Amendments to the Drawings:

Application No. 10/800,844
Reply to Office Action of May 4, 2005
Annotated Marked-Up Drawings

FIG. 1

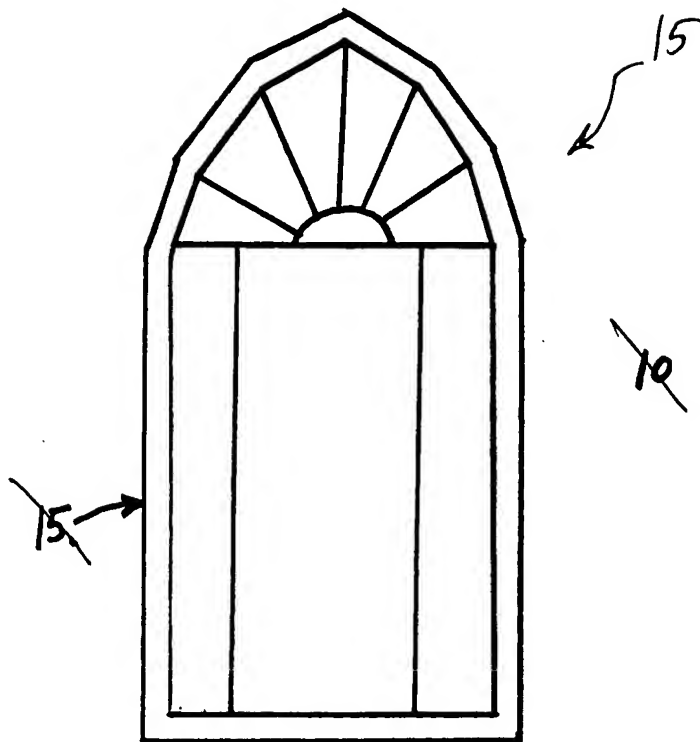
Corrected drawings in compliance with 37 CFR 1.121 (d) are submitted for consideration by the examiner. These corrected drawings are submitted to resolve the examiners objection under 37 CFR 1.83(a) for the features: “interior wall” and “recess”. Figs. 7-9 illustrate “interior wall” and “recess” features and the interconnection of these features to positively position and define the article and the function of the article claimed in this invention.

FIG. 3

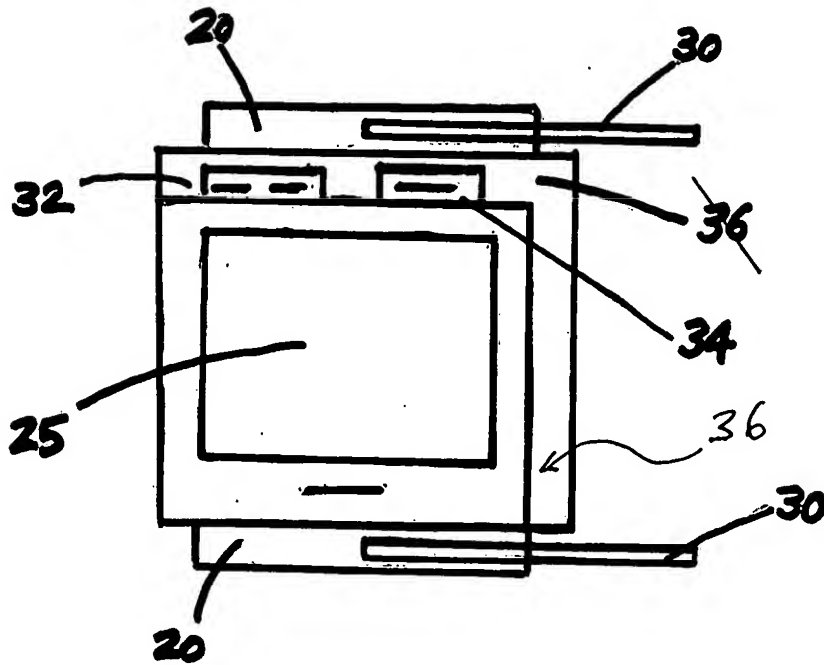
~~10~~
